CONSTRUCTION SUMMARY

Forestside Estates Inc.

LOT NUMBER	PHASE	HOUSE TYPE	CLOSING DATE
2	8	BLUE ELM (38-04A5) - ELEV A - 5 BEDRM	08-Aug-24

LOT 2 - 38-04 . The Blue Elm . El. A . 5 Bedroom . 3355 SQ. FT.

**BASEMENT
ELEV. A**

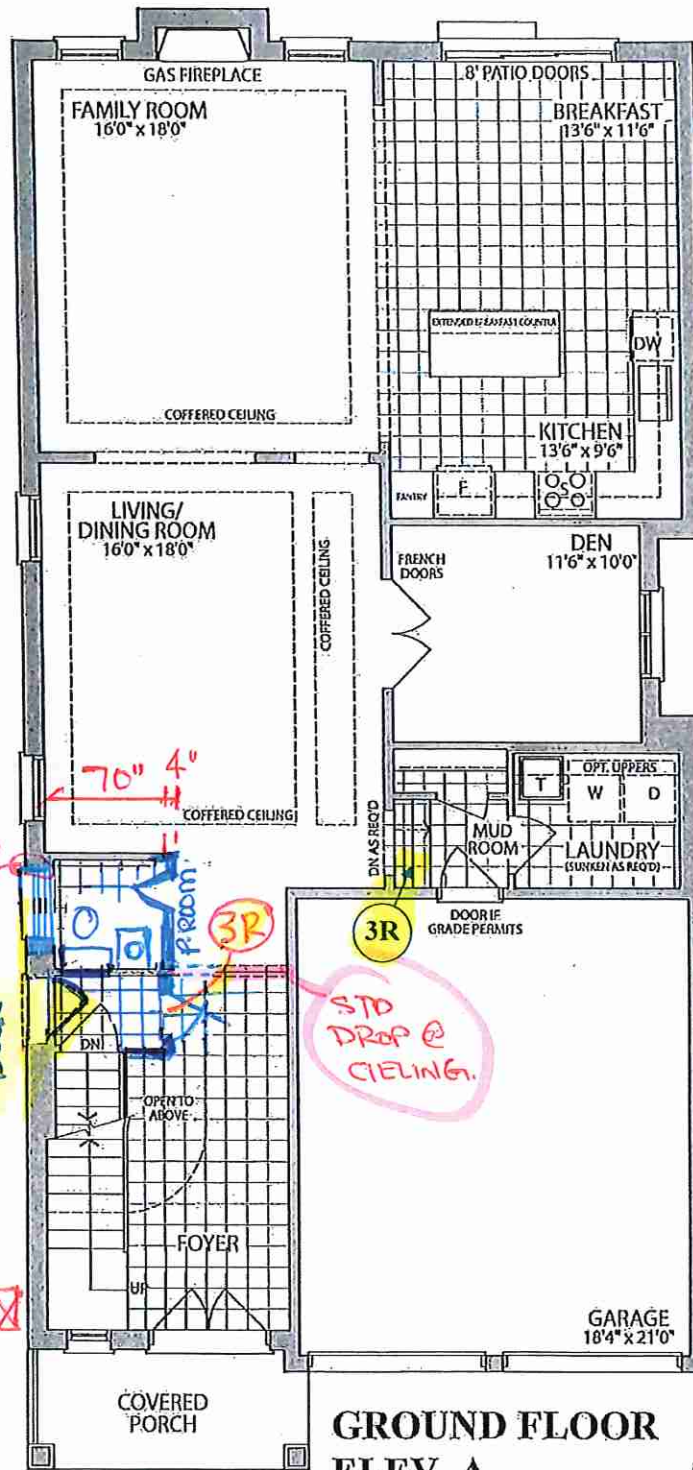
1 - BASEMENT- Purchaser declined the extended height basement ceiling Note:
2 - BASEMENT - WINDOWS - Install TWO (X2) larger basement windows in lieu of the standard basement windows. Windows to be approximately 30" x 24" with possible window well.(See Sketch) Note:
1 - BASEMENT - ELECTRICAL - Install 200 amp service to the home (SeeSketch) Note:
1 - SIDE EXTERIOR - Install OPTIONAL SIDE DOOR on the exterior (if grade permits).To include applicable exterior coach light (See Sketch) Note:
1 - MAIN HALL - DELETE - Delete the main hall closet next to the powder room. Delete the standard doors, applicable shelf and rod (See sketch) Note: **Approved as per Tony**
1 - POWDER ROOM - Close the entrance to the powder room from the lower landing and relocate to the main hall area. Powder room to entrance to be from the main hall. Rearrange powder room sink and toilet to accomodate new door location (See sketch) Note: Increase the powder room 2"-6" to accommodate the new location of the toilet and vanity to be a total of 5'-0" *Above Change included in item #4- As per Steve Approved by Tony

**GROUND FLOOR
ELEV. A**

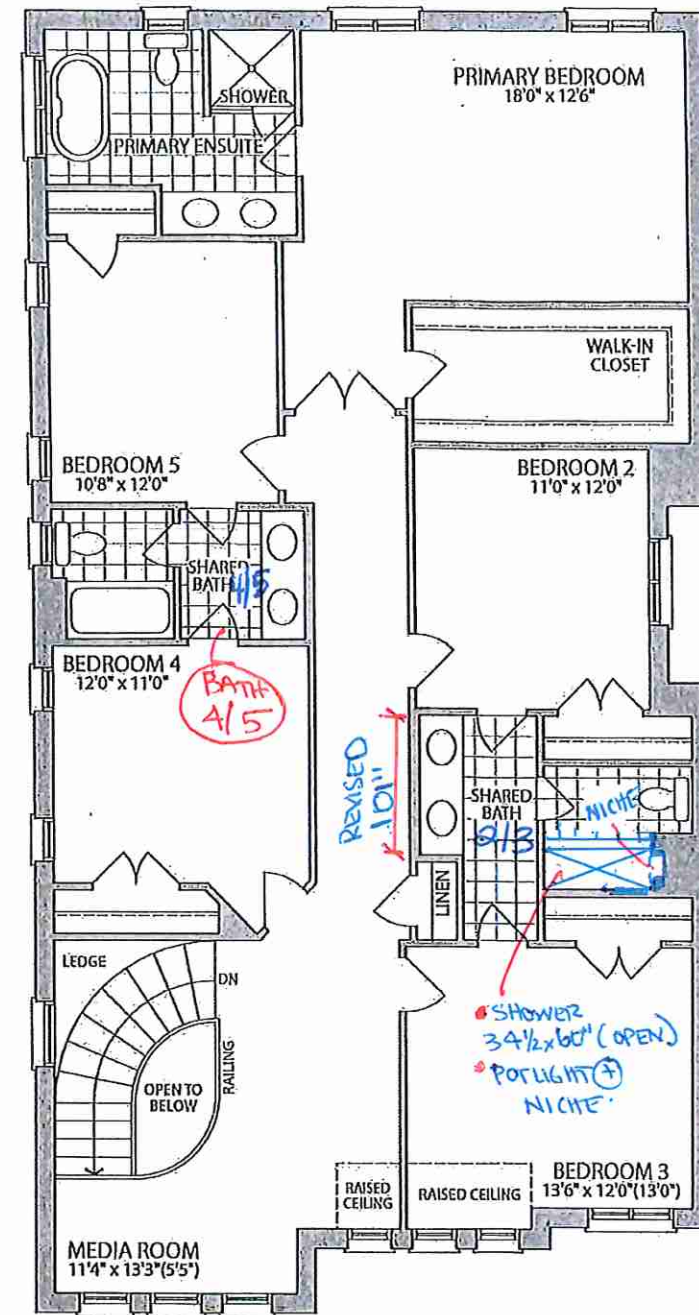
1 - MAIN FLOOR/HALL - STAIRS - Delete the risers leading to the lower landing and install a full wall with a standard interior door at standard height to the foyer . (See sketch) Note: **Approved as per Tony
1 - SHARED BATHROOM 2/3 - Delete the builders standard Tub/Shower and install SHOWER STALL. To include 2x2 mosaic floor, 6" curb with stone and shower pot light **To be left open (See sketch) Note:
1 - SHARED BATH 2/3- SHOWER- Install ONE (X1) shower niche in the shared bath 2/3 shower stall. To include white quartz in the niche. (See Sketch) Note: Purchaser does not want to delete the void spcae in the shower Install a 4" dummy wall to accomodate niche ONLY IF NEEDED Purchaser will have the option to furthur upgrade the colour of quartz at time of colour chart.
1 - PURCHASER AWARE AND ACCEPTS THAT ANY CHANGES MADE TO UPGRADES AFTER SIGNING THIS PURCHASERS EXTRA FORM ARE SUBJECT TO A MINIMUM ADMINISTRATION FEE OF \$1,000 Note:
